Service Bulletin No. LT20070717
Subject: Mast Support Guide Pin
Model: LT-12D
Product Group: Light Tower/Generator
Date: July 17, 2007

Series/Parts Affected:
All LT-12D series Light Towers within VIN range
Machines Affected/Trailer Vehicle Identification Number (VIN)
903838 - 904667

Figure 5. Preparing Mast Support Cradle

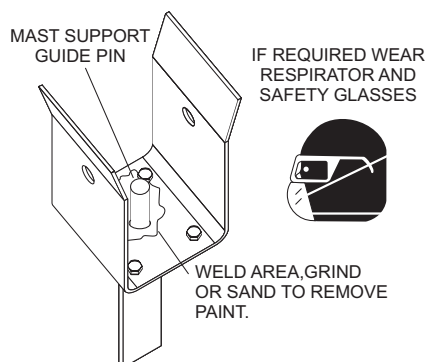
6. Perform the following when preparing the mast support guide pin for welding:
 - Remove paint from area to be heated during welding.

Figure 6. Mast Support Guide Pin Welding

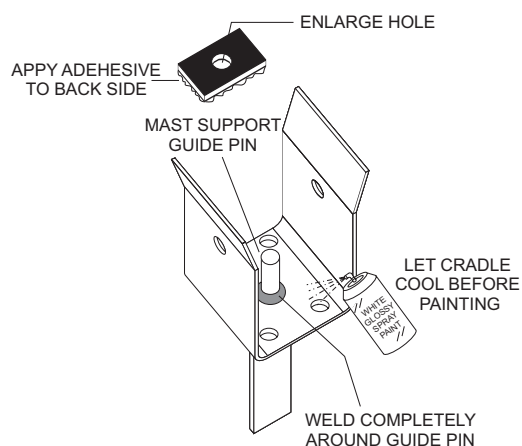
SERVICE INFORMATION
MANDATORY UPDATE: FAILURE TO FOLLOW INSTRUCTIONS MAY LEAD TO INJURY OR DEATH AND CAUSE SEVERE UNIT DAMAGE!
Problem: <ul style="list-style-type: none">• Mast Support Guide Pin may break off if impacted.• This condition may cause the mast to slide out of the receiver cradle during travel and <i>may lead to injury or death and severe unit damage!</i>
Solution: Weld around the <i>Mast Support Guide Pin</i> on the top side of cradle.

6. Using either the stick or MIG wire feed method of welding; weld area around mast support guide pin (Figure 6). Locate welder ground clamp as close to the mast support cradle as possible.
7. At the completion of the welding process, remove any burrs or rough edges surrounding the mast support guide pin.
8. Clean area around guide pin with a wire brush, then paint guide pin area with **white glossy spray paint**. Let mast support cradle cool before painting.

Use a 7018 (3/32-inch) stick with a rod current setting of 60 to 80 amps or lower. Fine tune as necessary.

Set voltage to 20.5, with a wire speed feed rate of 275 inches/minute. Fine tune as necessary. Use 0.035-inch mild steel solid wire with a mixture of 75% argon and 25% CO₂.
